PROJECT NAME St Marys Medical Center
 LOCATION 1102 Million Dollar Highway, St. Marys,

CUSTOMER: Hallstrom Construction, Inc.

Altoona Pipe And Steel Supply
 1128 Ninth Avenue
 Altoona, Pa 16603-0112
 (814) 944-1631

DESCRIPTION: HOIST BEAM & RTU SUPPORTS		DRAWN BY: TMc
PROJ. NAME: St Marys Medical Center	DATE: 01/02/2011	CHKD. BY: TAN
LOCATION: 1102 Million Dollar Highway, St. Marys, PA.	DATE: 02/25/2011	JOB No. 3-21375
CONTRACTOR: Hallstrom Construction, Inc. ARCH/ENG: KTH Architects, Inc./Lee-Simpson Assoc., Inc.	DATE: 02/25/2011	REV. 1
Altoona Pipe And Steel Supply Co. 1128 Ninth Avenue Altoona, Pa 16603-0112 (814) 944-1631

PLAN AT EL. 1893'-11-1/4

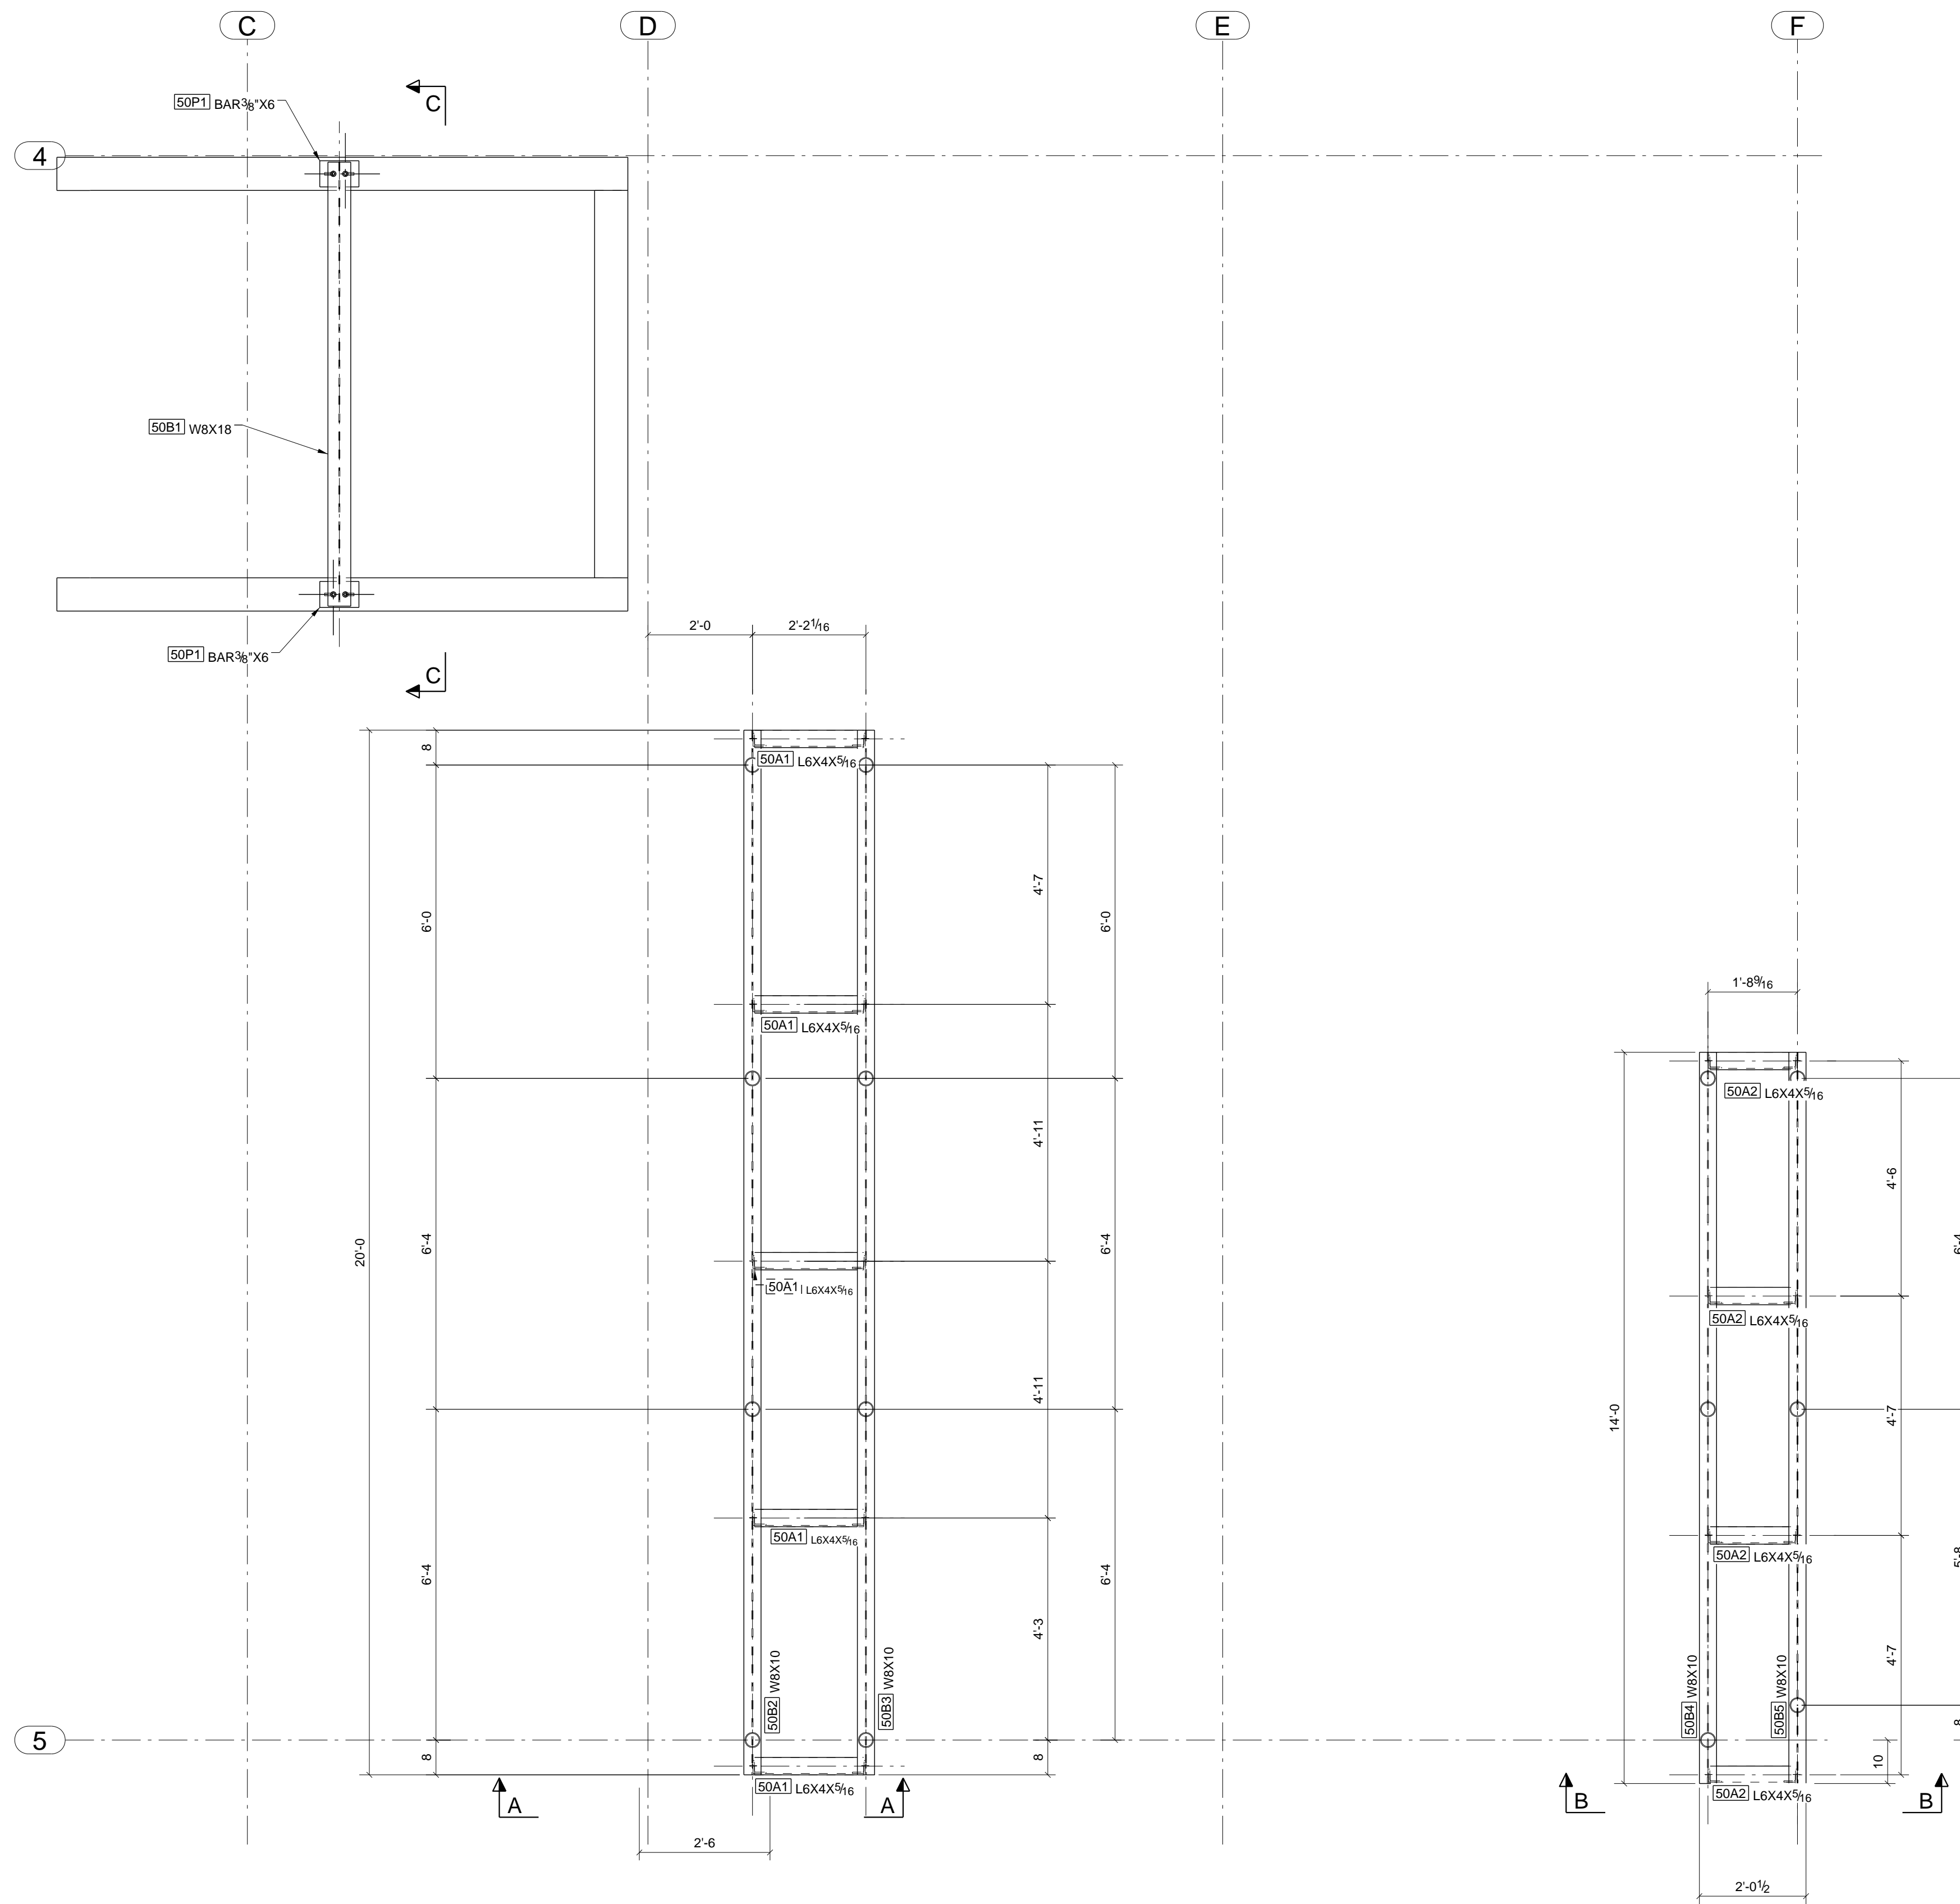
CONTRACTOR, PLEASE COORDINATE WITH FABRICATOR IF CMU WALL WILL BEAR ON PLATES AS SHOWN OR BE BUILT THRU ROOF STEEL AND CUT TO FIT AROUND BEAMS
